**AERONAUTICAL CHARTING MEETING**  
**Instrument Procedures Group**  
**Meeting 20-02 – October 27, 2020**

**RECOMMENDATION DOCUMENT**

**FAA Control #20-02-355**

**Subject: Minimum Enroute Altitudes (MEAs) Published on Standard Instrument Departures (SIDs) and Standard Terminal Arrivals (STARs)**

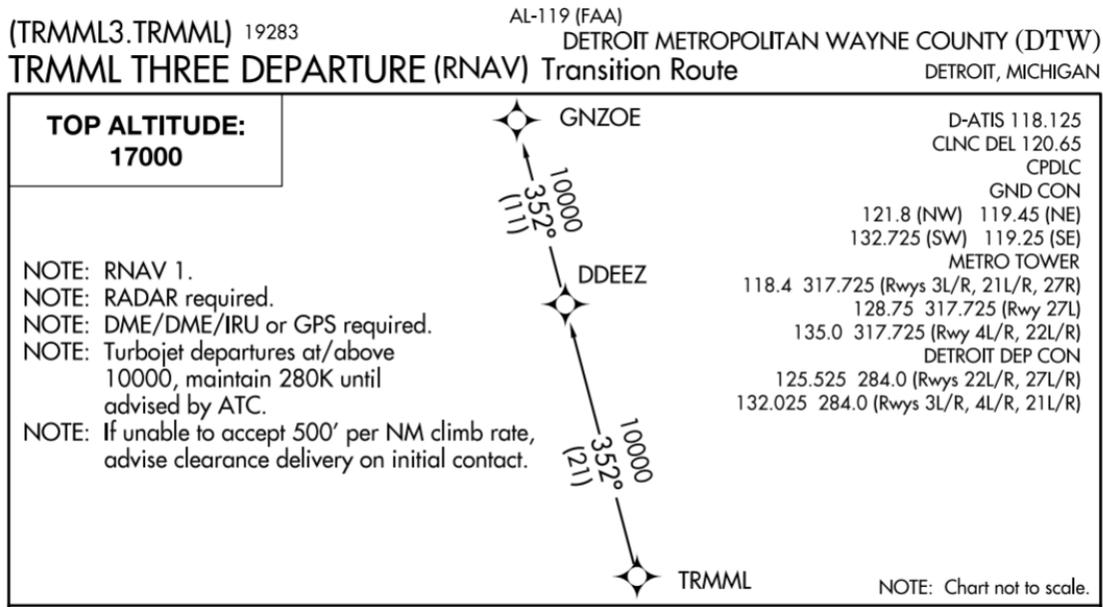
However, these changes to the 8260-series orders have failed to prevent the publication of ATC operational MEAs on SIDs and STARs. NBAA's research reveals that this failure is the direct result of conflicting guidance published in an Air Traffic Order used by the Flight Procedures Teams when assessing DME/DME coverage on SIDs and STARs that appears to be used in priority over the guidance furnished in the 8260-series orders.

Specifically, the conflicting guidance is found in the Order JO 7470.1A, Distance Measuring Equipment (DME)/DME Infrastructure Evaluation for Area Navigation (RNAV) Routes and Procedures, in paragraph 10.b(2)(b)(i) and (ii):

Unfortunately, the guidance provided above in this Air Traffic order is resulting in higher than required MEA altitudes to support ATC purposes contrary to the 8260-series guidance and expressed desires of the ACM. As result, we are still seeing higher than necessary MEAs being published on SIDs and STARs because of this conflict between FAA Orders. An example is shown below on this recently published SID at Detroit (DTW):

Amend Order JO 7470.1A, Distance Measuring Equipment (DME)/DME Infrastructure Evaluation for Area Navigation (RNAV) Routes and Procedures to bring the MEA restrictions on SIDs and STARs in conformance with the guidance furnished in the applicable 8260-series orders.

If necessary, update the TARGETS automation program and the RNAV Pro DME/DME assessment procedures to conform with the requirements for MEA altitudes in the applicable 8260-series orders.
